K1T804 Series Terminal V1.2.0_build190513 Release Note (2019-05-23)

| Device Model: DS-K1T804F/MF/EF | Firmware Version | ARM: ACS_1T_M0_EN_GM_V1.2.0_build190513 MCU: ACS_Extending_Module_GML_GM_V1.2.0_build190505 |

Local EHOME Setting

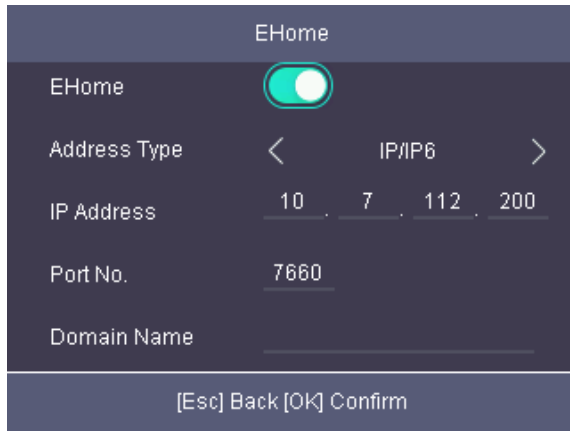
1. Person information structure changes from "based on card" to "based on person ID";
2. Support a new authentication mode: card/fingerprint/password;
3. Support attendance status (check in/check out/break out/break in/overtime in/overtime out);
4. Basic settings will be saved automatically when you quit configuration menu. Some important configurations such as EHOME settings and restore device settings will still ask for confirmation before saving;
5. Support EHOME 4.0 and 5.0, can be configured in local interface or client software;

Multiple Languages

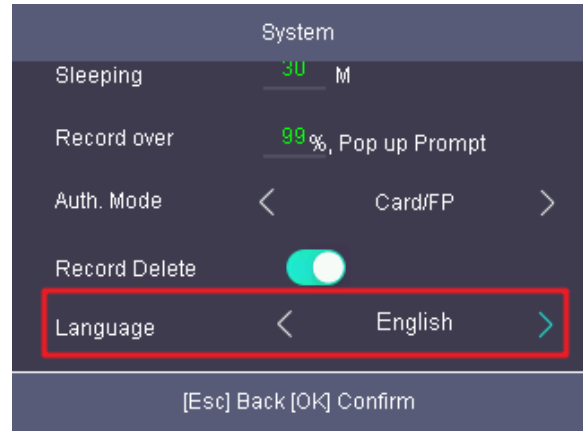
6. Multiple languages and voice prompts: English, Brazilian Portuguese, Spanish, French, Vietnamese, Italian, Arabic, Thai.
